project. Sherwood Library Renovation | 1225 Wonderland Rd N, London, ON

project no. 23-006

This Addendum is issued before the award of Contract to inform the Contractor of certain modifications to the work described in the Drawings and Specifications dated September 18, 2024.

end of addendum | 002

DRAWN BY: U.E. **CHECKED BY:** M.D./W.A.
PROJ. MGR/ARCH:
APPROVED FOR CONSTRUCTION DATE:
PLT DATE/TIME: 2024-10-10 1:30:08 PM
PROJECT NO.: P-BIMSR-22-51
REVISION NO.: J **SHEET NO.:** E101

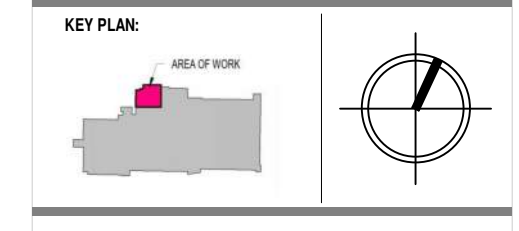
1.17	<p>Question: What does LSP mean on drawing E101 right hand side of drawing.</p> <p>RESPONSE: Library Settlement Partnership. The library settlement workers speak a variety of languages, and can help with common questions about moving to Canada.</p>

<p>1.19</p>	<p>Question: On drawing E101, “power outlet spec” note A and B. Can you provide a spec on these so they can be priced accordingly. Also after looking at the drawings I cant tell which receptacles this is referring to? Can you please clarify?</p> <p>RESPONSE: Type A: Two Duplex Power/USB outlet EQUAL: DECORA CSA TYPE 5-15R, 120V 15A Type B: Remove.</p>
<p>1.20</p>	<p>Question: Is the electrical trade to rough in for power operated doors (push buttons) and provide power to openers? And the remainder, hardware and low volt wiring by others?</p> <p>RESPONSE: No power door operators/push buttons. Please refer to revision on E101, to provide card reader and associated back box and conduit to door D108.</p>
<p>1.21</p>	<p>Question: Is the electrical trade to rough in for security only? Wiring and devices by others?</p> <p>RESPONSE: See response to 1.14 above.</p>
<p>1.22</p>	<p>Question: On drawing E101, there is mention of “under carpet cable conduit”. I didn’t notice in the drawings anywhere about raised floors or any detail on it. Is the floor to be saw cut and carpeted over and still be accessible to the raceway? Can you please clarify.</p> <p>RESPONSE: As per the drawings, under carpet power and data is required. Connectrac “Flex Raceway System” has been specified:</p>  <p>See link for additional info: https://connectrac.com/connectrac-flex-raceway-system/</p>

<p>1.35</p>	<p>Question: Is there missing demolition drawings for the existing power and lighting that needs removed in the existing area? I don't see any demo scope on these electrical drawings. Drawing E101 shows a dashed line for “Data distribution – cable tray” in one location on the drawing and then shows “conduit in bulkhead” in another location. – There is no bulkhead shown on the reflected ceiling plan in the area of this dashed line. Is it safe to assume cable tray is to be installed above the T-BAR/GRID Ceiling? Is there a size of cable tray required or a spec to follow for this cable tray?</p> <p>RESPONSE: Correct. The cable tray shall be installed ABOVE the new T-BAR / GRID Ceiling.</p>
<p>1.36</p>	<p>Question: Some workstations are shown to be fed with connectrac back to columns and others are not. Is it safe to assume all free standing work stations in the open area are to be fed with connectrac raceway system?</p> <p>RESPONSE: For the freestanding table located between Gridlines E/F and 4/5, remove the AC/USB outlet. All others will be fed by Connectrac.</p>

<p>1.44</p>	<p>Question: Drawing E101 notes a blue dashed line indicating 'Data distribution - Cable Tray' it later changes to 'Conduit in bulkhead'. The RCP does not show a bulkhead here. Please confirm if this is to be run free air above the ceiling, or if a cable tray should extent from the IT room all the way to the games room.</p> <p>RESPONSE: There is no conduit in the bulkhead, this note is to be removed.</p>
<p>1.45</p>	<p>Question: Is security (wiring, hardware, card readers, sensors, panels), data cabling, server racks, AV (projectors, screens, tv's, kiosks), POS system, by others?</p> <p>RESPONSE: GC to install all required conduits and infrastructure for all security, data, pos, bas systems. Third party systems to be installed by others.</p>
<p>1.46</p>	<p>Question: Is all trenching for the power and data lines, and under carpet Connectrac in contract?</p> <p>RESPONSE: Yes. Trenching and Connectrac shall be in contract items.</p>

<p>1.50</p>	<p>Question: There five (5) receptacles shown on Dwg E101 that are unclear if they are under carpet Connectrac. They are located at the columns on gridline 6 @E&F and at the table noted as AC USB between gridlines 4&5 and E&F. Please clarify if these are in-floor or not.</p> <p>RESPONSE: The four receptacles indicated on Gridline 6 at E and F will be fed from the ceiling and installed within the furring walls around the existing column. Exact locations will be coordinated on-site with the owner after final furniture selection is made. For the freestanding table located between Gridlines E/F and 4/5, remove the AC/USB outlet.</p>
